# **ADDENDUM NO. 1**

## 5P468-22-0077/A

Phase 8 – North Mountain Slope Stabilization OL4079 / RL4086 Cape Breton Highland National Park, Inverness County, Nova Scotia

## Drawing G05 (G01/G03)

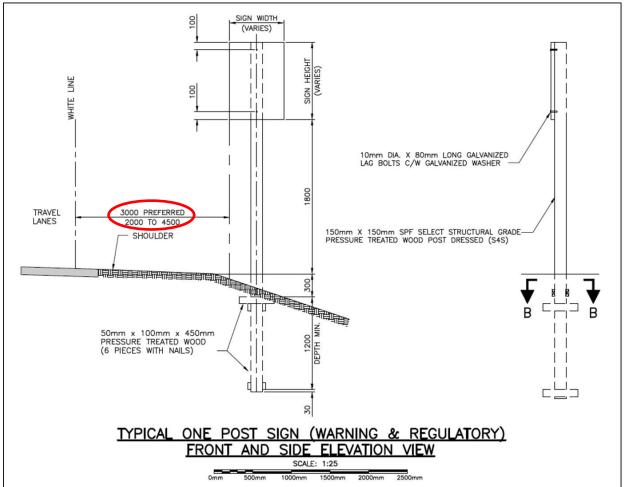
a) Add new sub-drawing numbered 2D titled: "TYPICAL ONE POST SIGN (WARNING & REGULATORY) 2D" to be included as G01/G03 as with other sub-drawings 2A to 2C. With the following viewpoint: "FRONT AND SIDE VIEW ELEVATION" Drawing 2D as below:

b) For additional drawing G01/G03 "TYPICAL ONE POST SIGN (WARNING & REGULATORY) 2D" Change the dimension circled in red ("3000 preferred") to the following: "DIRECTION OF THE DEPARTMENTAL REPRESENTATIVE"
